LINCOLN CITY/LANCASTER COUNTY PLANNING STAFF REPORT

P.A.S.: Special Permit #1984

PROPOSAL: Brian Carstens, on behalf of David L. and Doreen K. Miller, has requested a Special Permit for a parking lot on residentially zoned property.

**Special Permit #1984
S. 17th & Washington St.**

EXISTING TREE LAYOUT

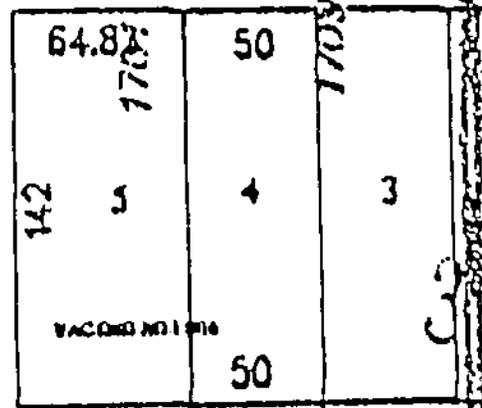
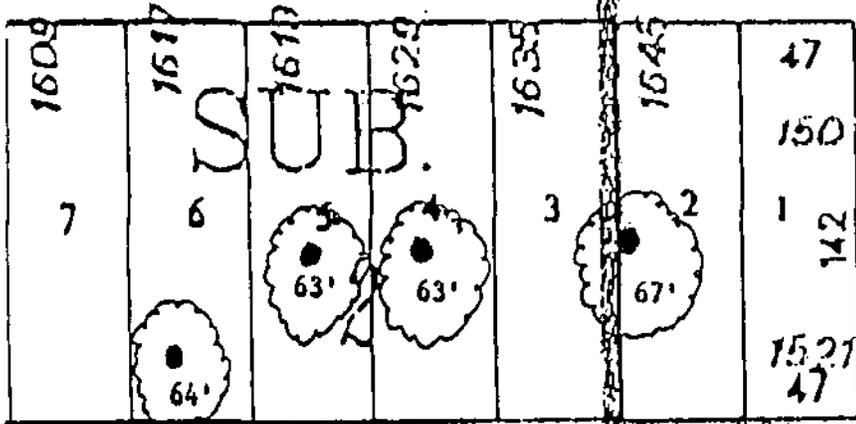
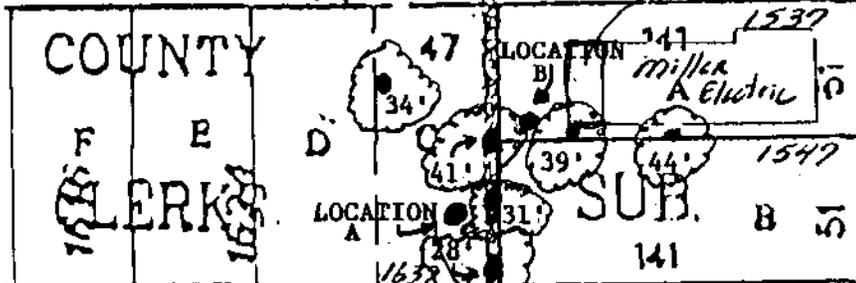
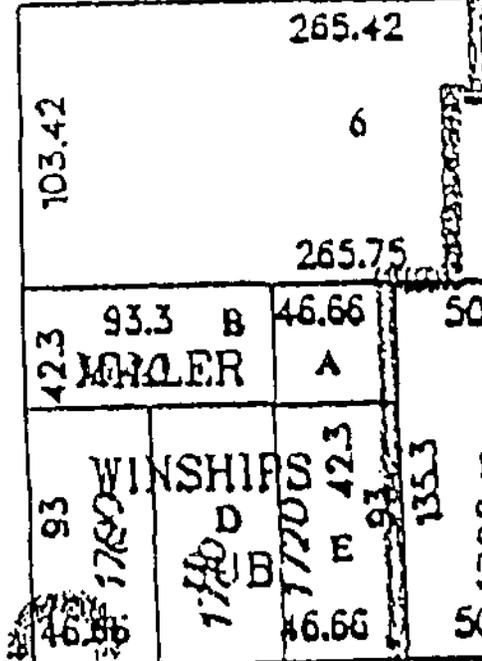
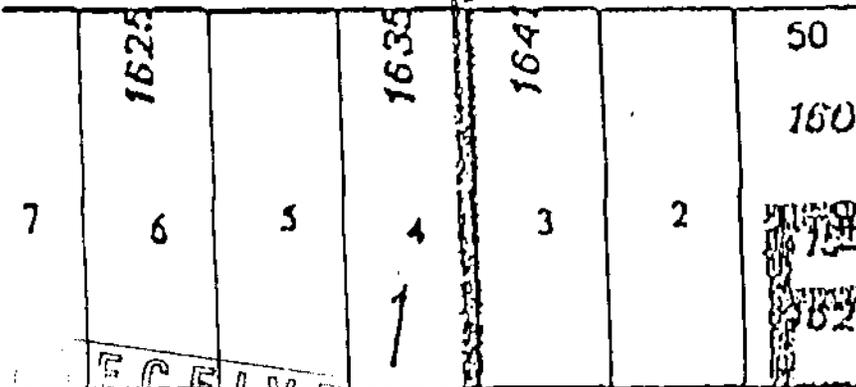
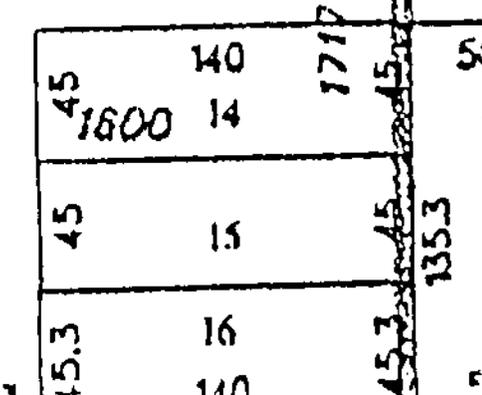
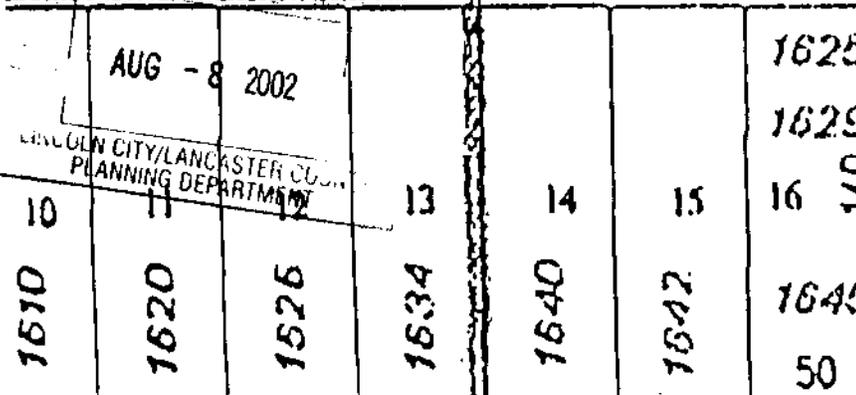
3. PUBLIC WORKS RESPONSE: The Public Works and Utilities Department has noted that the required 17.5' depth of the accessible parking stall intrudes into the required 22' driving aisle.

ALLTEL, Time Warner Cable, and the Lincoln Electric System will require the additional easements marked in red on the map.

- The required 17.5' depth of the accessible parking stall intrudes into the required 22' driving isle.

- As noted in the response to the previous submittal for Special Permit #1984, the required 17.5' depth of the accessible parking stall intrudes into the required 22' driving isle.

1. Landscape Plan should include street trees.

1.1.1 That the required 17.5' depth of the accessible parking stall does not intrude into the required 22' driving aisle, per request by Public Works

1.1.2 Add the additional utility easements required by L.E.S.

1.1.3 Remove the drive from the parking lot to the future building.

1.2.1 Screening and landscaping that meet the City of Lincoln Design Standards

1.2.5 Add the required street trees to meet current standards.
